ADDENDUM NO. 2

December 9, 2022

BAILLY ELEMENTARY SCHOOL ADDITIONS AND RENOVATIONS Chesterton, IN 46304

Addendum Two (AD.02) to the drawings and specifications prepared by Gibraltar Design for **Bailly Elementary School Renovations** for Duneland School Corporation, Chesterton, Indiana.

UNIT "A" FIRST FLOOR
REFLECTED CEILING PLAN

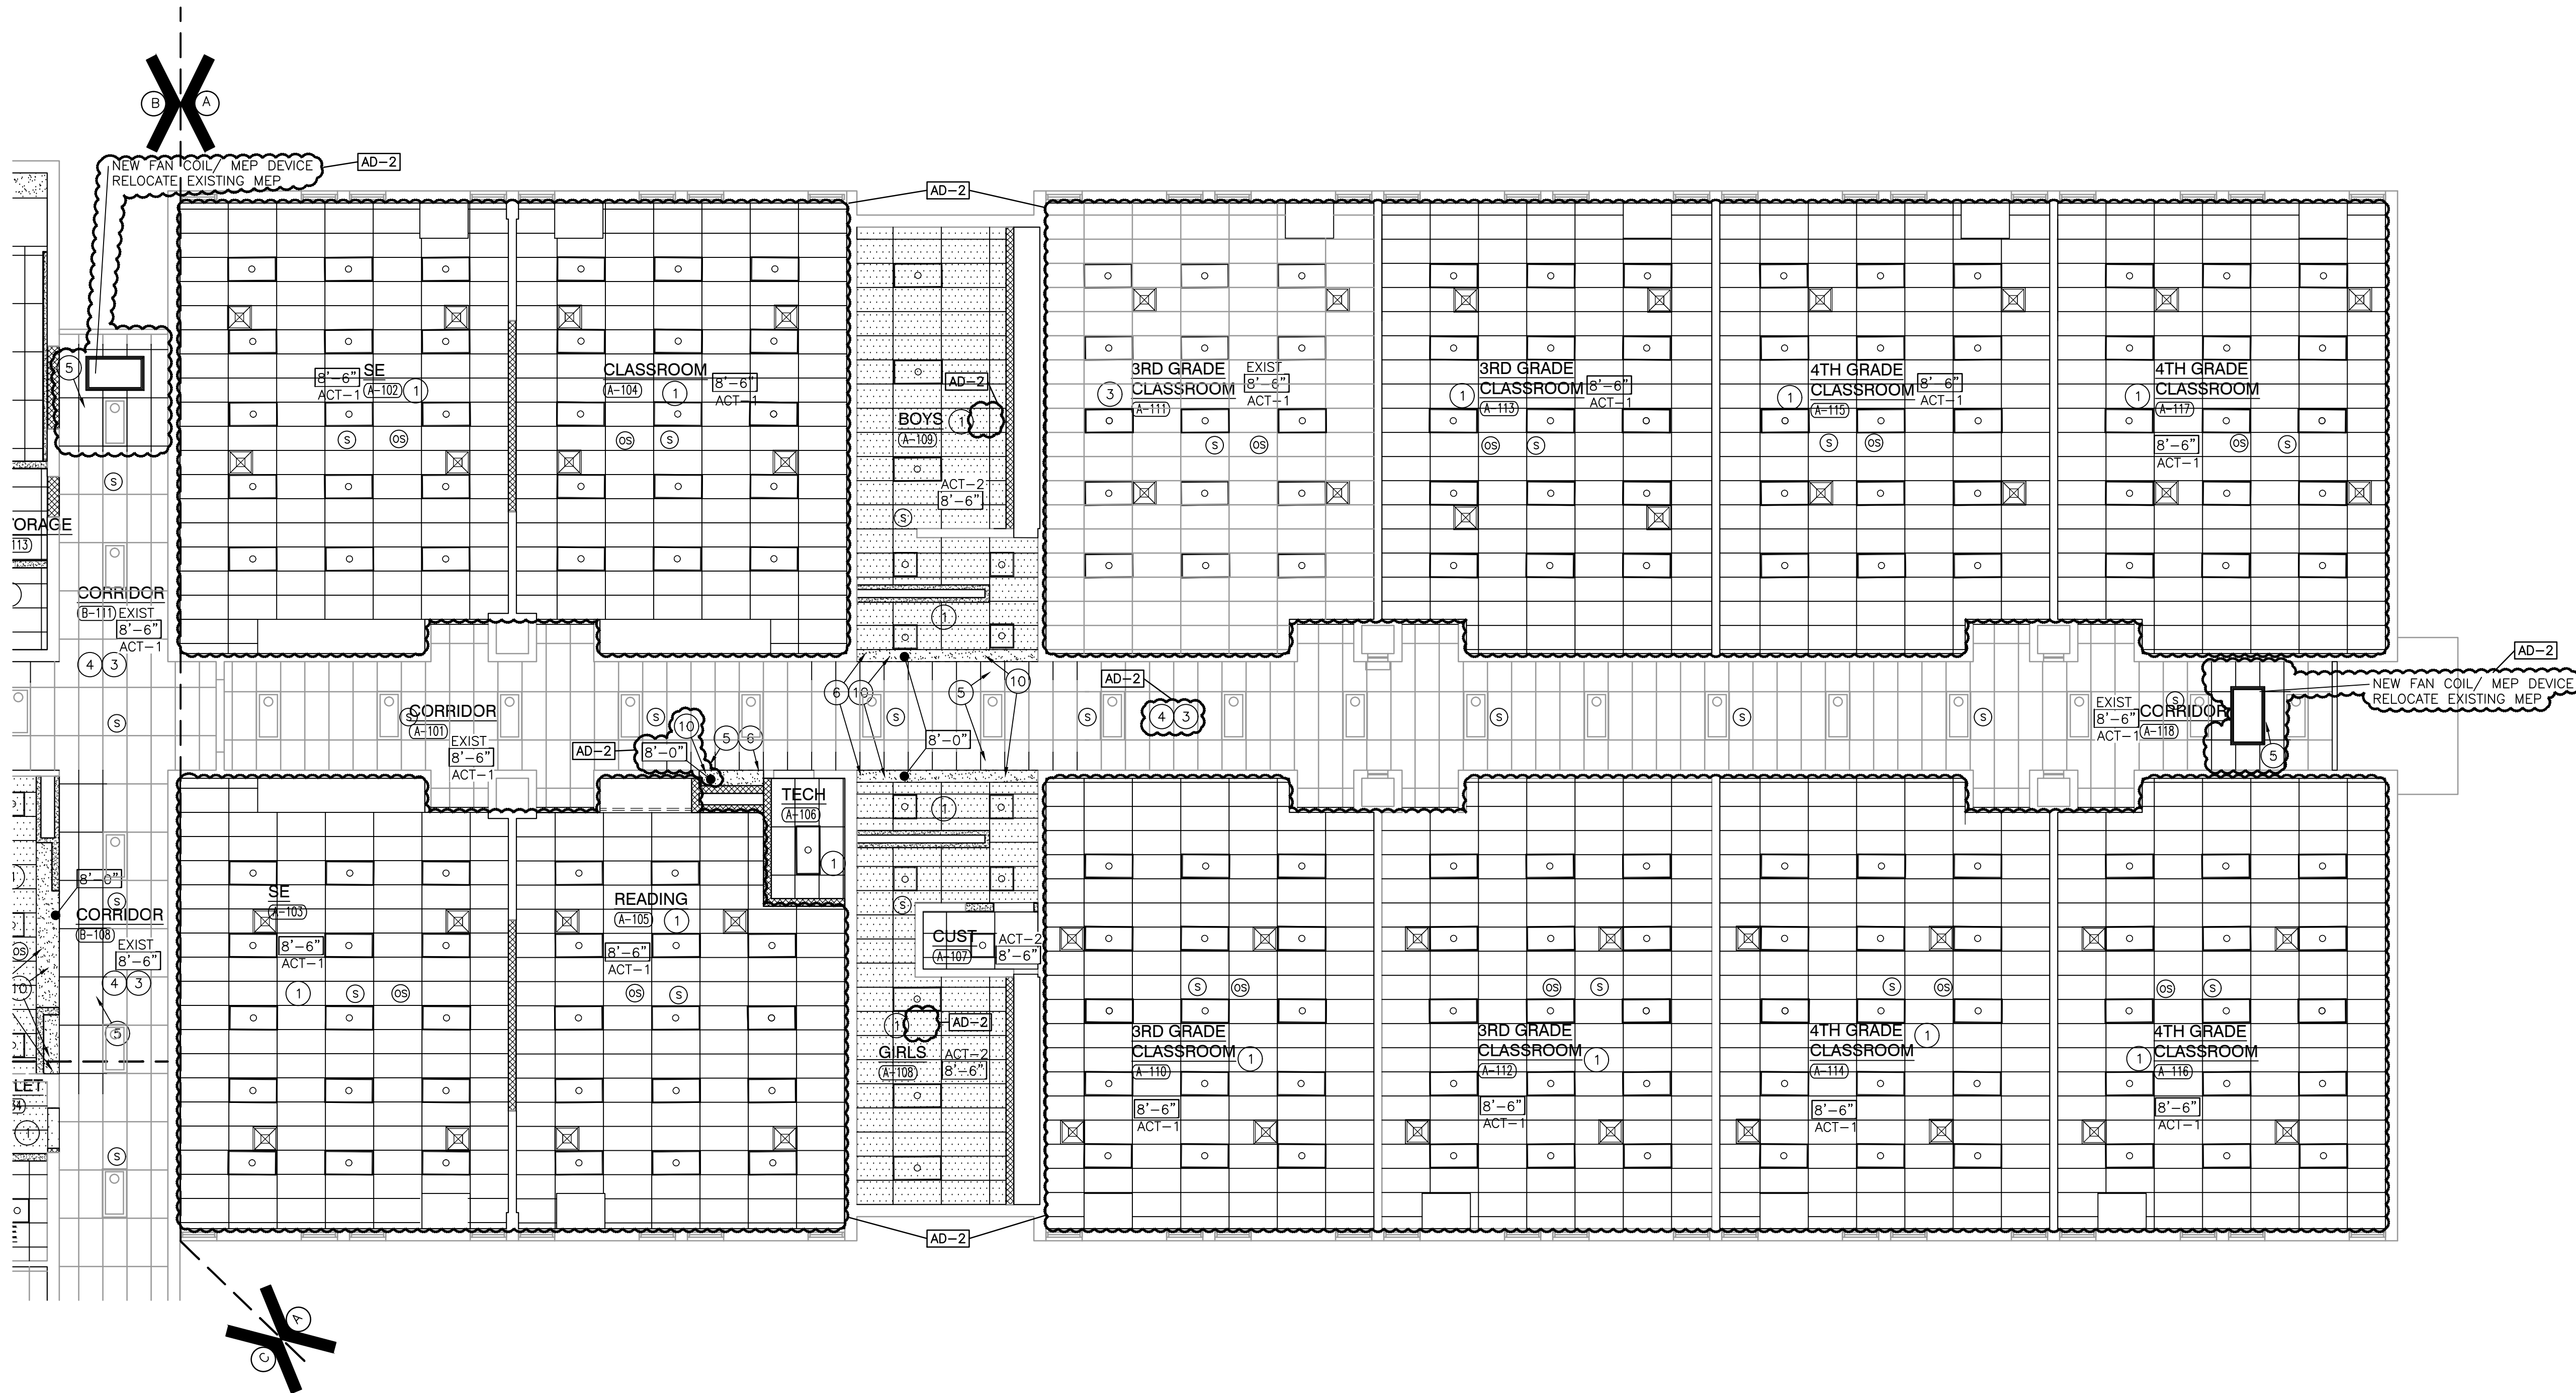
- A. Refer to revised full size drawing included in this addendum for the following revisions:
1. Update ceiling orientation in the following rooms: SE A-102, SE A-103, Classroom A-104, Reading A-105, 3RD Grade Classroom A-110, 3rd Grade Classroom A-111, 3rd Grade Classroom A-112, 3rd Grade Classroom A-113, 4th Grade Classroom A-114, 4th Grade Classroom A-115, 4th Grade Classroom A-116, 4th Grade Classroom A-117.
 2. Update Drinking Fountain alcove ceiling bulkhead as indicated in Corridor A-101.

3. Update to indicate ceiling grid and pad modification and ceiling mounted cabinet heater in Corridor A-118.
4. Update to indicate new acoustical ceiling grid, pads and suspension system in the following rooms: SE A-102, SE A-103, Classroom A-104, Reading A-105, 3RD Grade Classroom A-110, 3rd Grade Classroom A-112, 3rd Grade Classroom A-113, 4th Grade Classroom A-114, 4th Grade Classroom A-115, 4th Grade Classroom A-116, 4th Grade Classroom A-117.
5. Update Boys A-109, Girls A-108 for removal of a note.

UNIT "B" FIRST FLOOR
REFLECTED CEILING PLAN

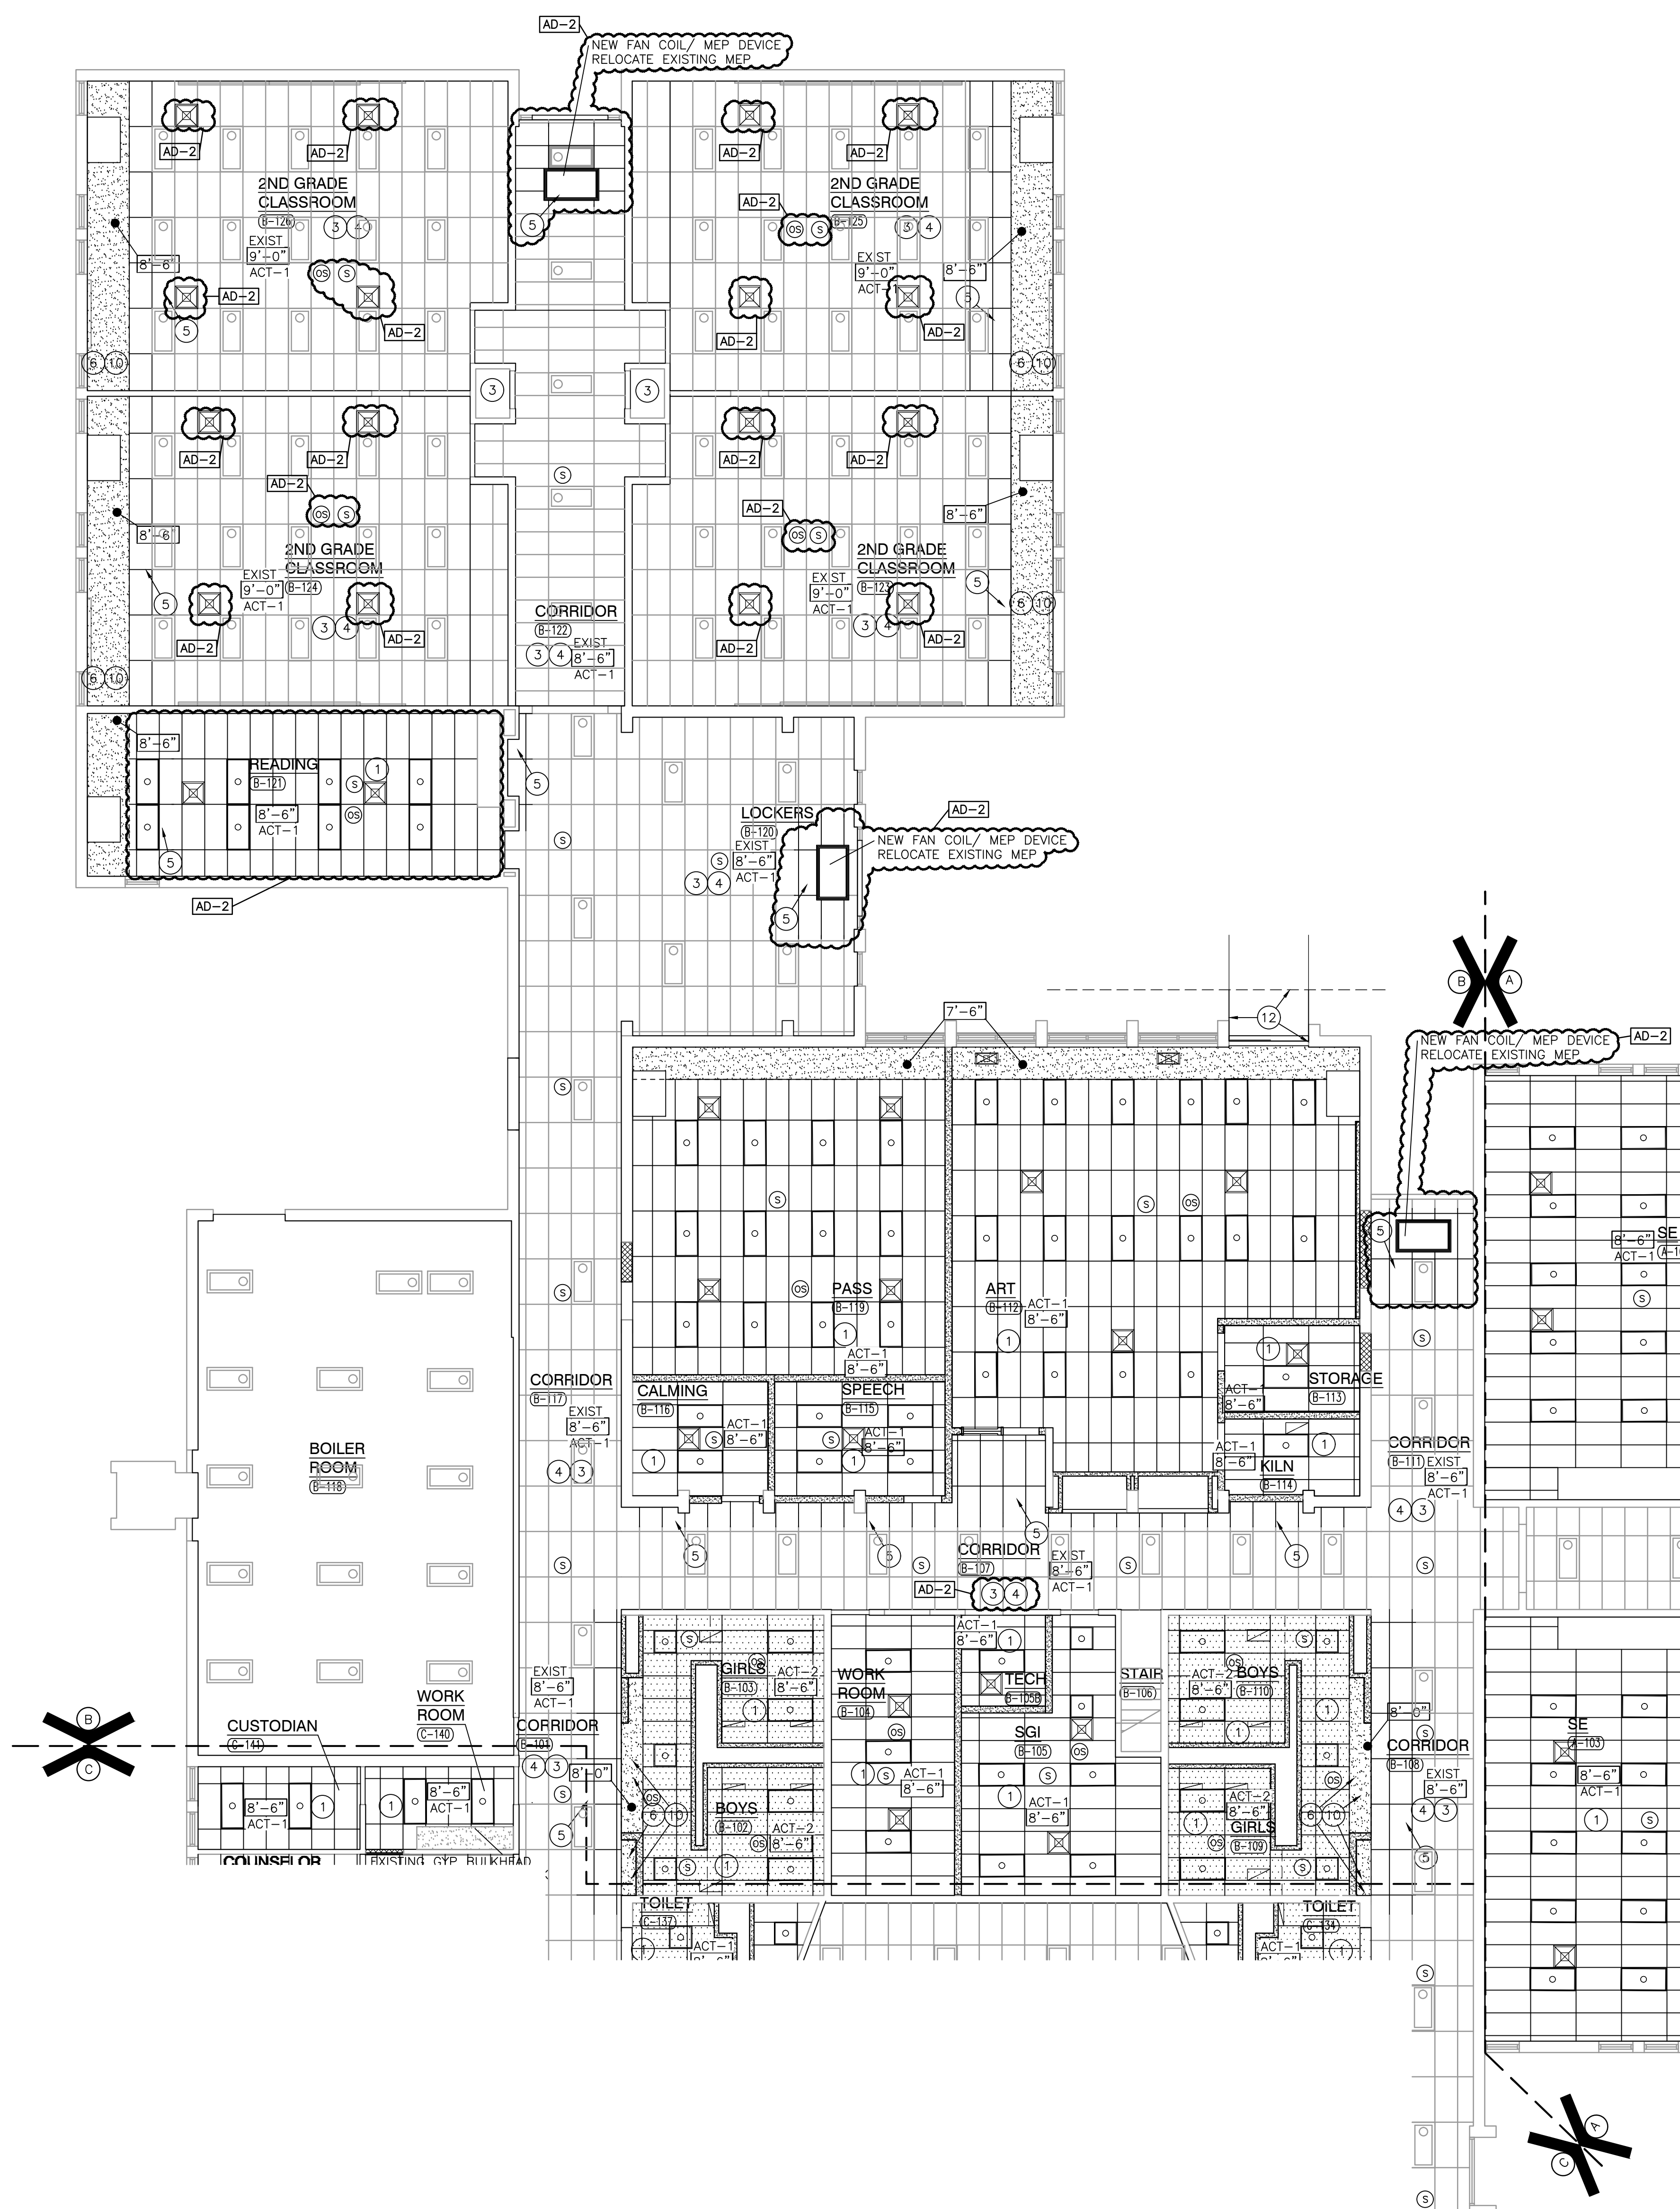
- A. Refer to revised full size drawing included in this addendum for the following revisions:
1. Update ceiling orientation in the following rooms: Reading B-121, 2nd Grade Classroom B-123, 2nd Grade Classroom B-124, 2nd Grade Classroom B-125, 2nd Grade Classroom B-126.
 2. Update to indicate ceiling grid and pad modification and ceiling mounted cabinet heaters in Corridor B-122, B-111, and Lockers B-120.
 3. Update to indicate new acoustical ceiling grid, pads and suspension system in Reading B-121.
